MONITORING YEAR 6 ANNUAL/CLOSEOUT REPORT

GLADE CREEK II RESTORATION PROJECT

RE: Monitoring Year 6 (MY6) Report – Draft Submittal
Glade Creek II Mitigation Project
DMS Project # 92343
Contract Number 6843
New River Basin - CU# 05050001 - Alleghany County, North Carolina

Wildlands Engineering, Inc. (Wildlands) has reviewed the Division of Mitigation Services (DMS) comments from the Draft Monitoring Year 6 report for the Glade Creek II Mitigation Project. DMS's comments are noted below in **bold**. Wildlands' responses to those comments are noted in *italics*.

Figure 2 Project Component/Asset Map
 Glade Creek II Restoration Project
 DMS Project No. 92343
 Monitoring Year 6/Closeout - 2021

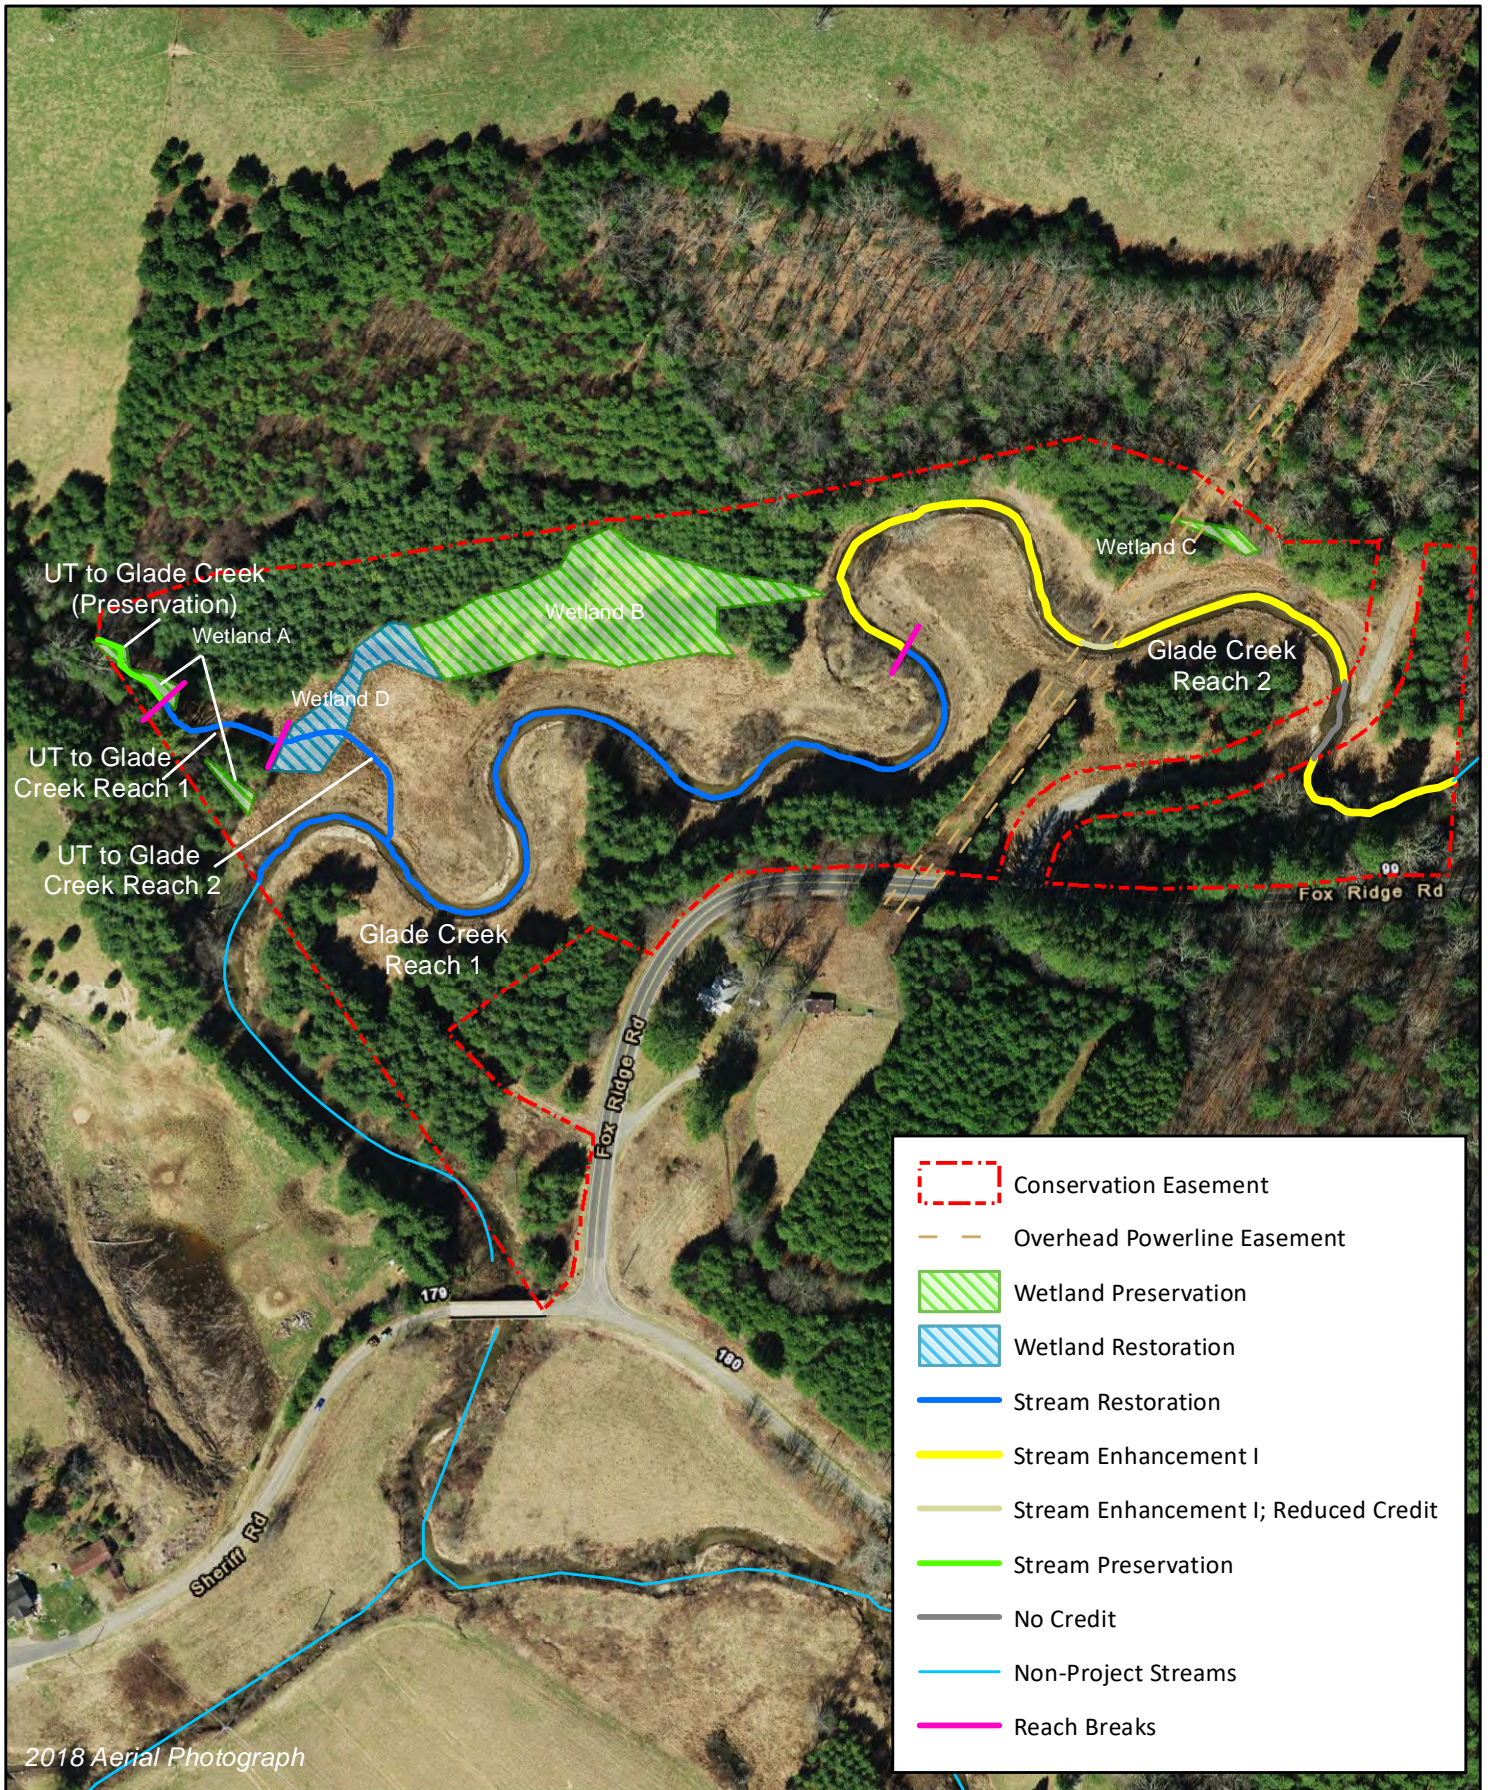
DMS comment: Aerial photos appear washed out/yellow on the hard copies. If possible, please remove any opaque filtering and/or improve the print quality

Wildlands response: The transparency for the aerial imagery has been reduced to 0% to create a darker background in Figures 2 and 3.
